R2-B16

4/10/92

Subject: NRC Meeting At Westinghouse 4/8/92
 Review Progress On Solvent Extraction
 Contamination Problem

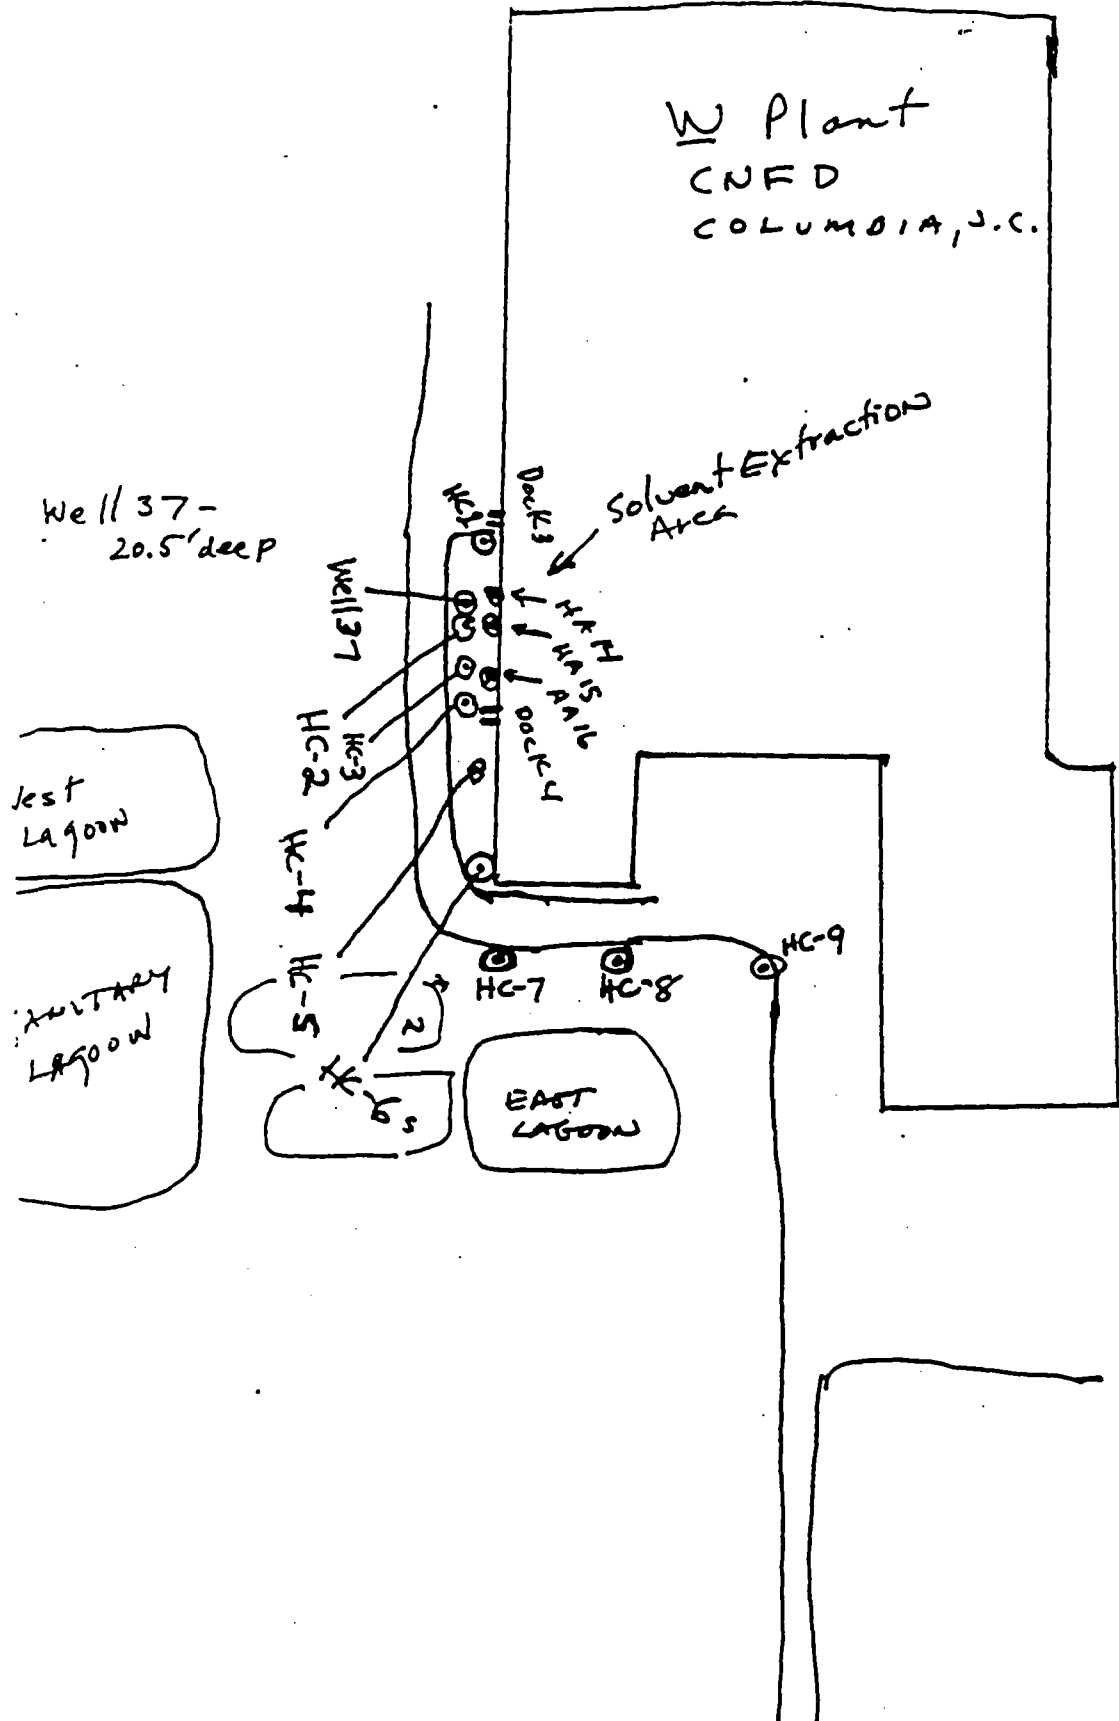
1. Evaluate the depth of the footers
2. Evaluate migration down the footers
3. Indicate site characterization numbers if any in report
4. Leak control procedure formalization
